**ADDENDUM NO. 2  
PROJECT BI-CTC-455**

Date: April 23, 2015  
Renovations and Addition to Lafayette Hall  
Housatonic Community College  
Bridgeport, CT

Renovations and New Addition to Lafayette Hall  
Housatonic Community College  
Bridgeport, Connecticut

This addendum is issued to show corrections, revisions and clarifications to the BID Documents Submission for the *Renovations and New Addition to Lafayette Hall at Housatonic Community College*, dated March 6, 2015.

AD2-A1

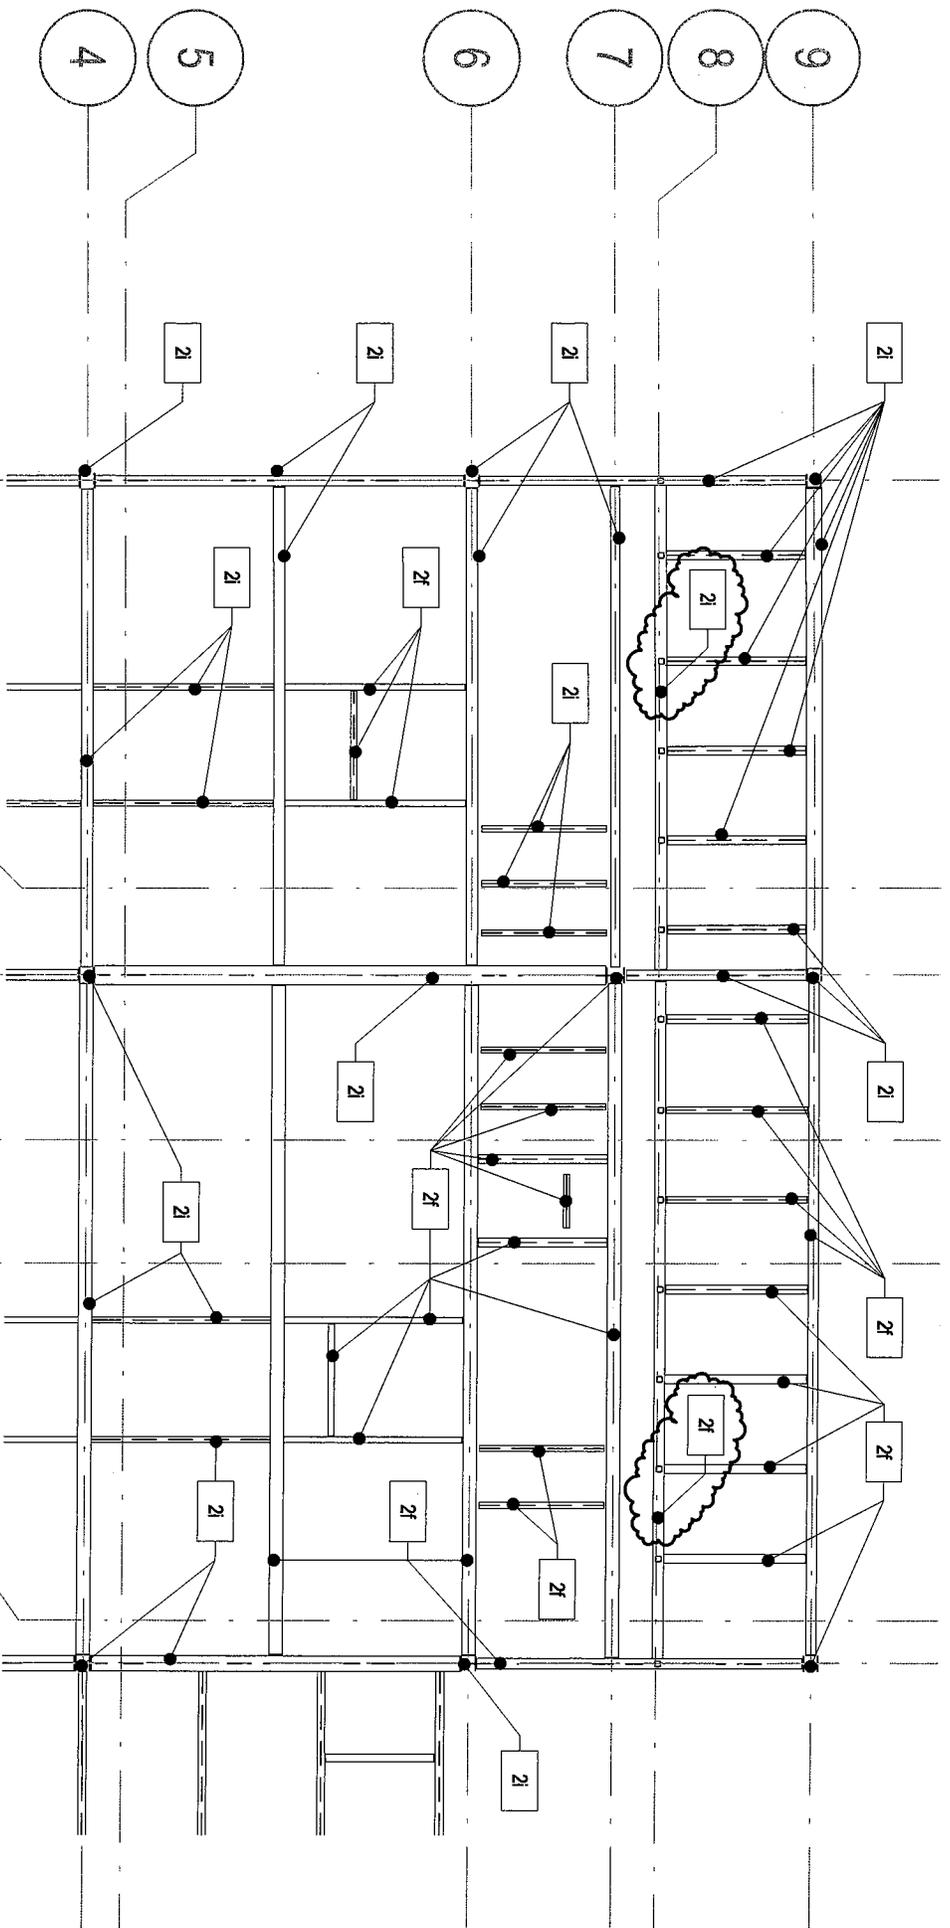
- Detail 28: **ADD** note to clarify electric range within Kiln Room as indicated on sketch AD2-A1.

AD2-A2

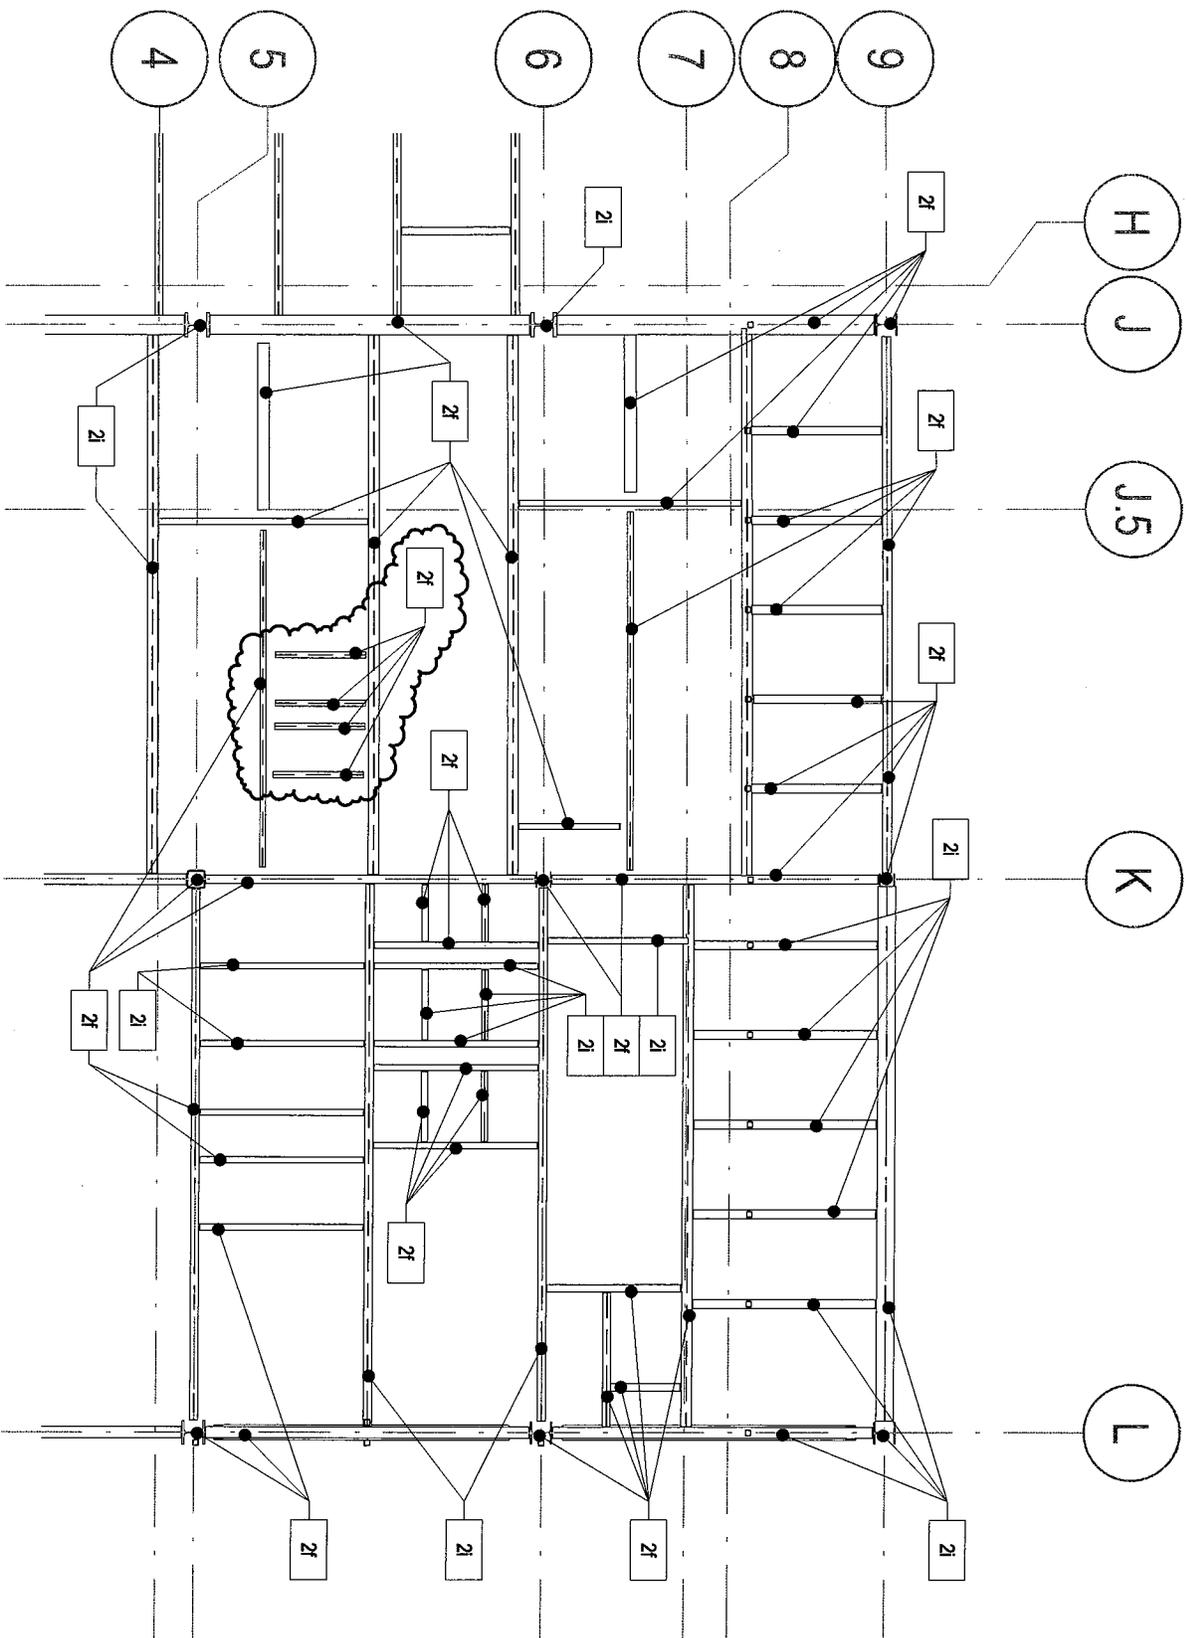
- Detail 13: **ADD** intumescent fireproofing to beam along grid line 8, between grid lines A and C as indicated on sketch AD2-A2.
- Detail 13: **ADD** applied fireproofing to beam along grid line 8, between grid lines C and G as indicated on sketch AD2-A2.
- Detail 13: **ADD** applied fireproofing to (4) beams between grid lines 5 and 6 and between grid lines J.5 and K as indicated on sketch AD2-A3.

**SECOND FLOOR FRAMING PLAN**  
 1/8" = 1'-0"

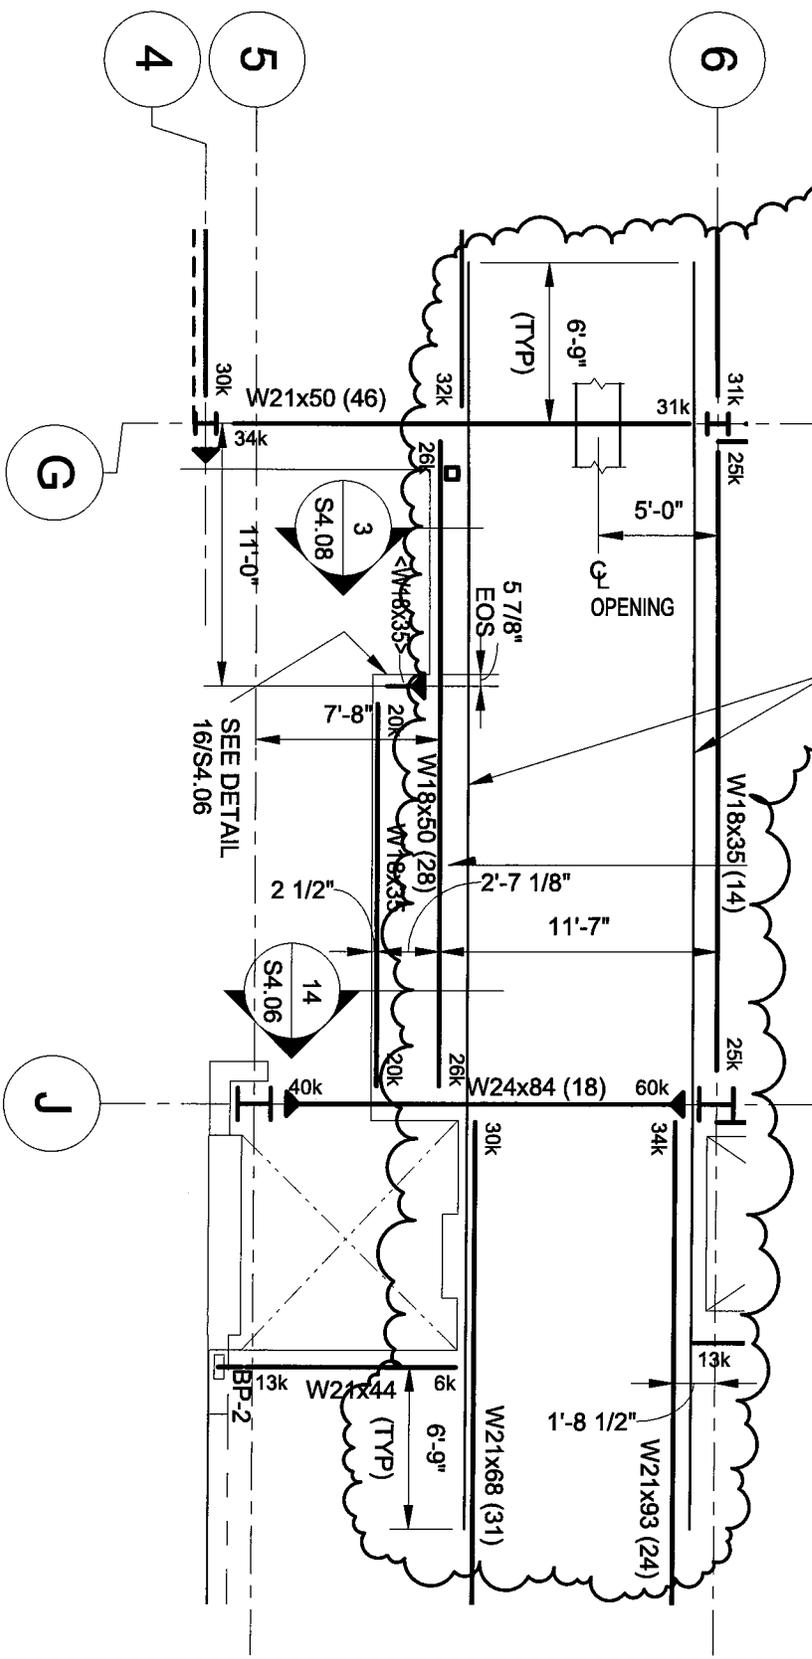
- Second Floor Framing Plan: **ADD** slab reinforcing as indicated on sketch AD2-S1.

(9) #8'S CONT @ 3" O/C PROVIDE A 1.3 Ld TENSION LAP SPLICE AS SHOWN ON "S3.01" AS REQ'D (TYP)

**AD2-S1**

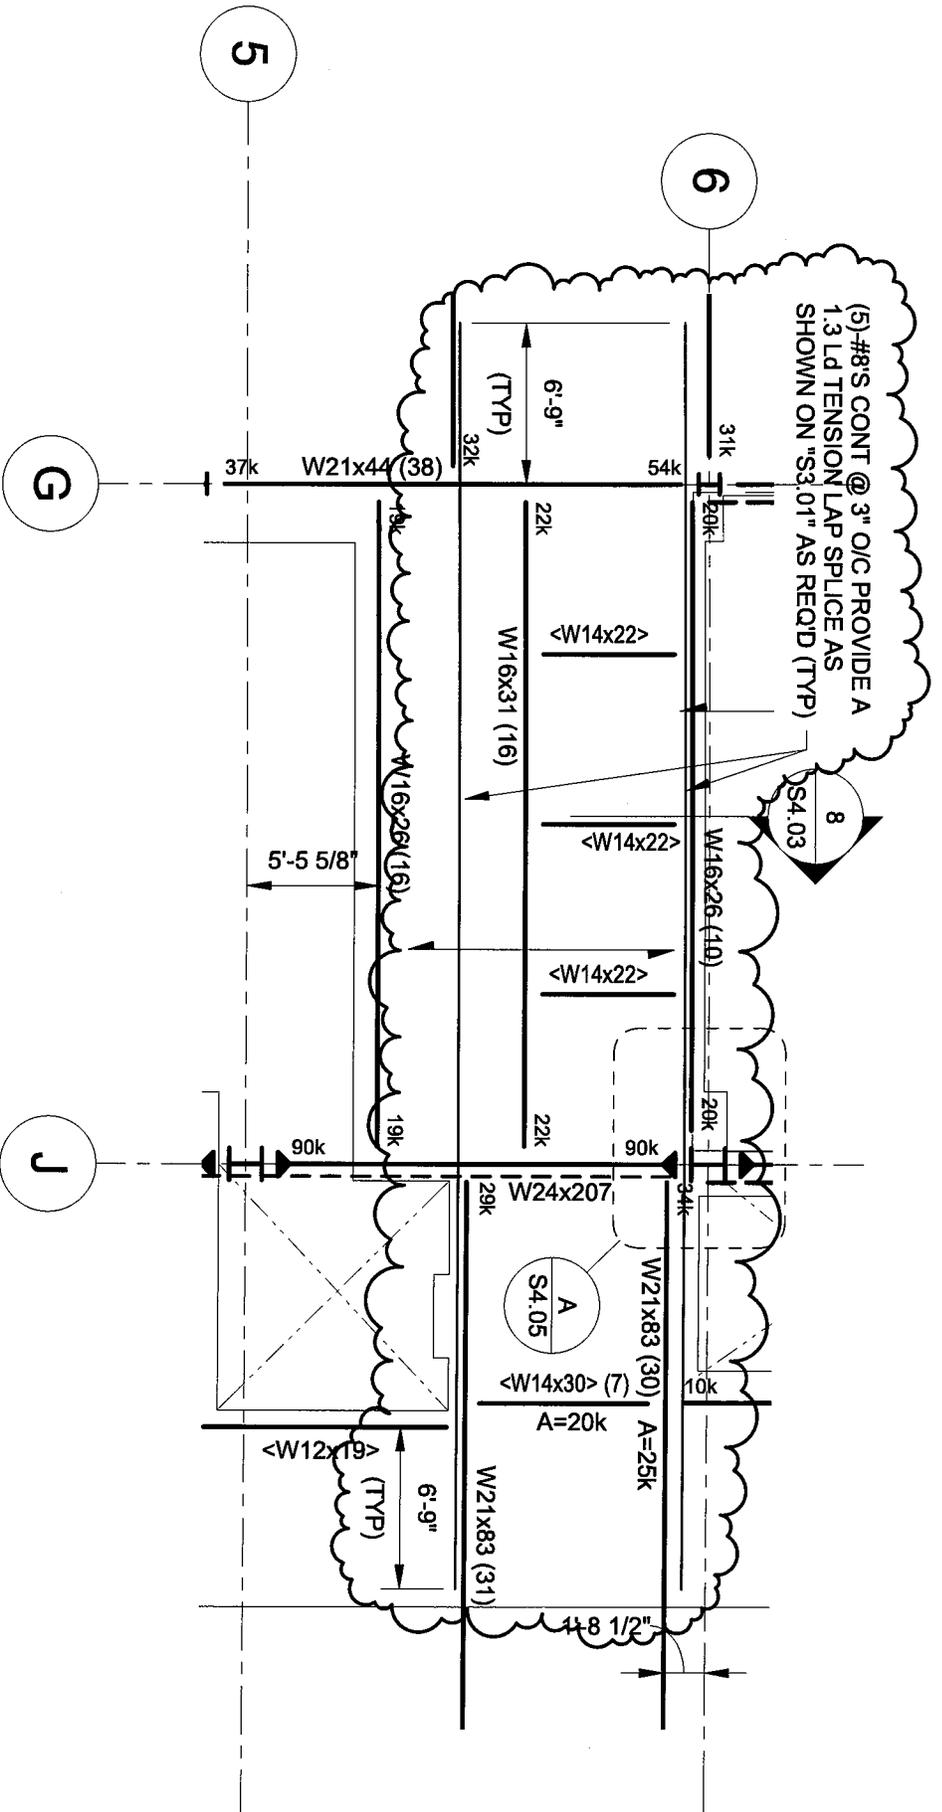
- Third Floor Framing Plan: **ADD** slab reinforcing as indicated on sketch AD2-S2.

**AD2-S2**

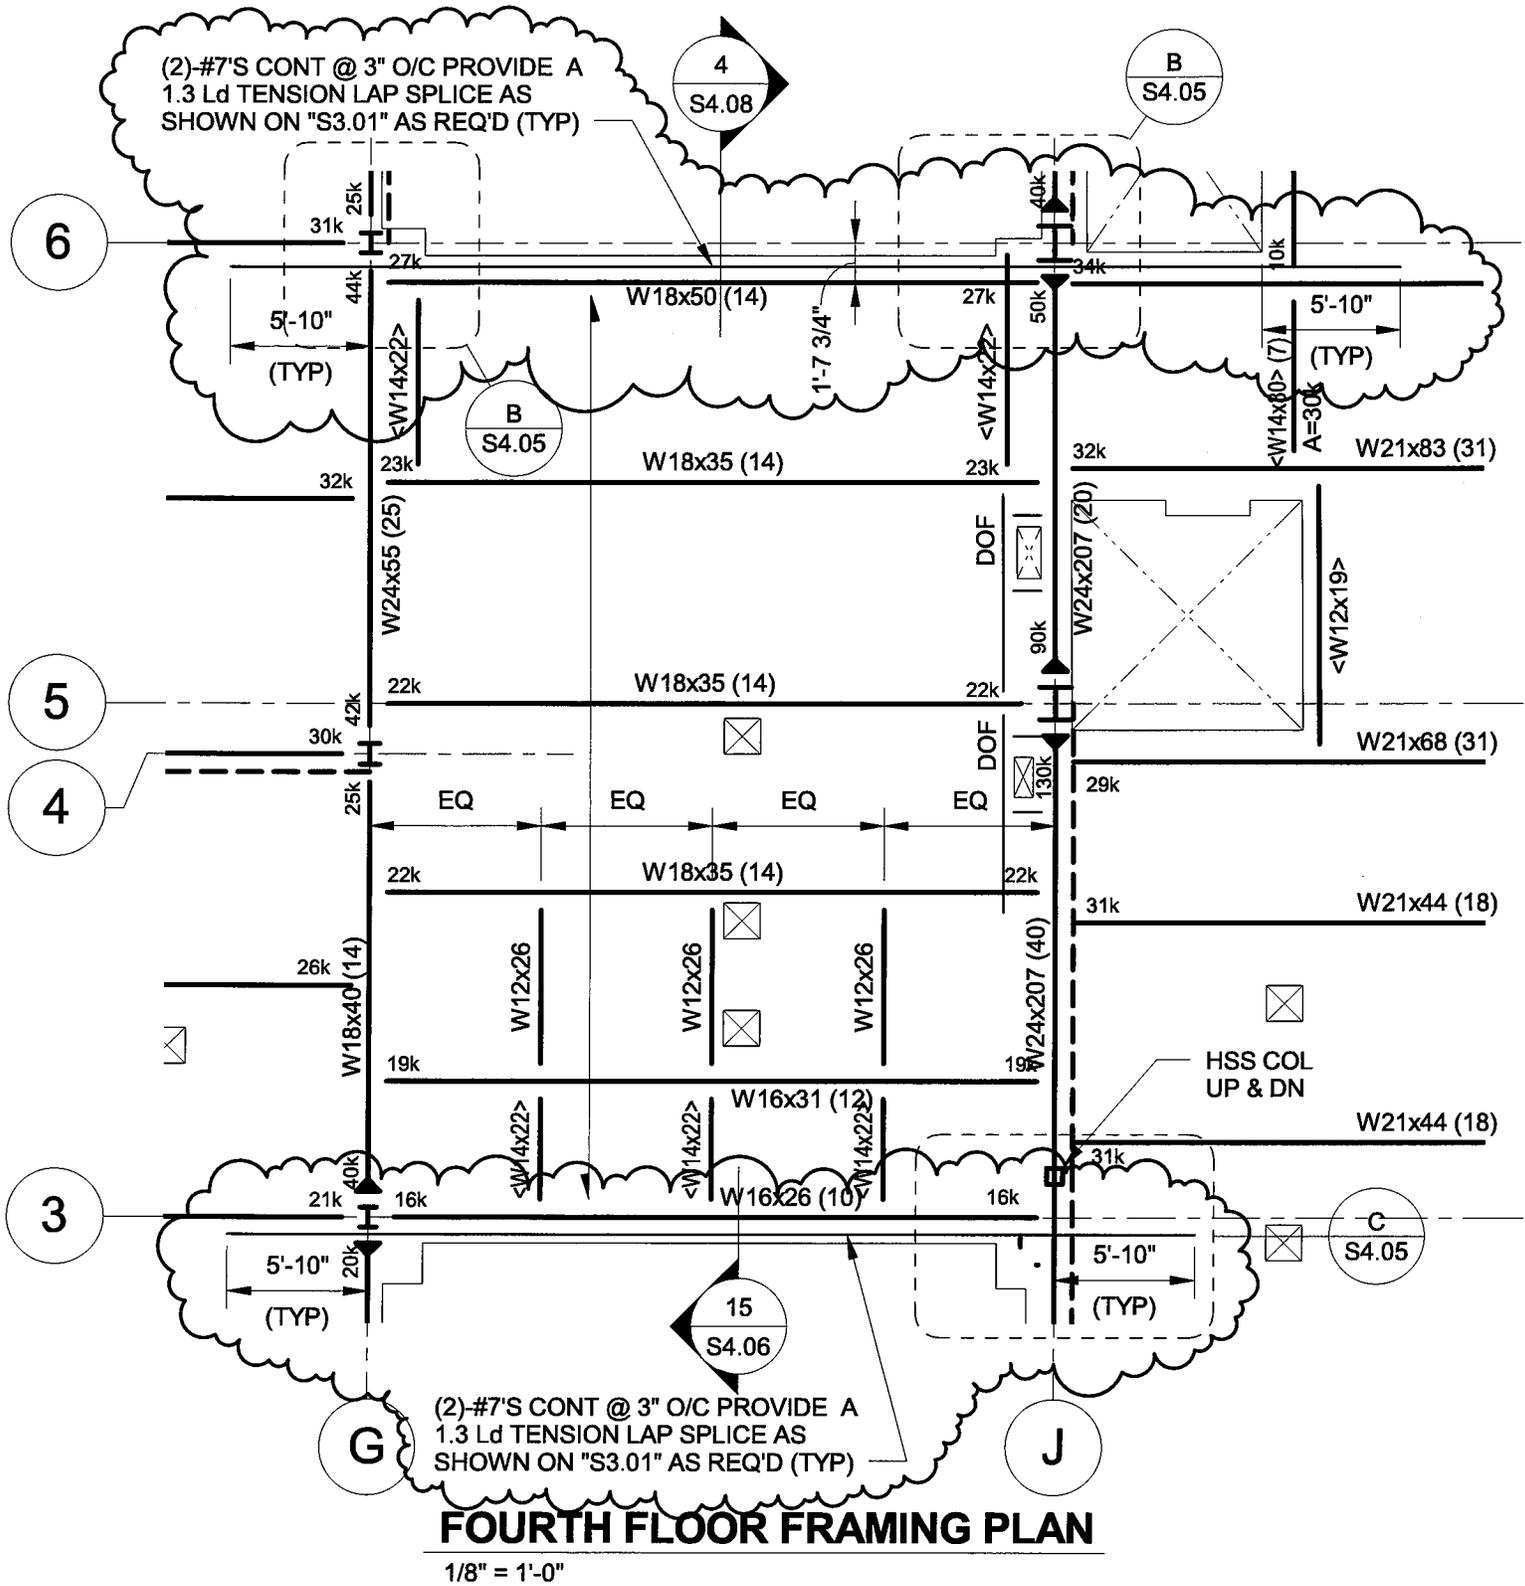
- Fourth Floor Framing Plan: **ADD** slab reinforcing as indicated on sketch AD2-S3.
